**REVISION 001 TO AN  
INVITATION TO TENDER**

<b>Title:</b> Rehabilitation of Spillway 2, Canal Lachine National Historic Site	
<b>Solicitation No.:</b> 5P201-20-0086/A	<b>Date:</b> December 14, 2020
<b>Amendment No.:</b> 001	
<b>Client Reference No.:</b> 1452	
<b>GETS Reference No.:</b> PW-20-00930900

## **Amendment 001**

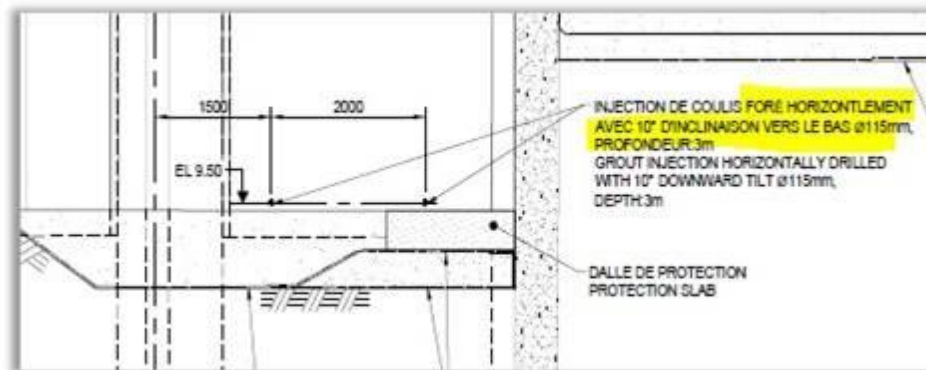
b. Are the stone blocks cemented together?

**A3** : No, see attached picture
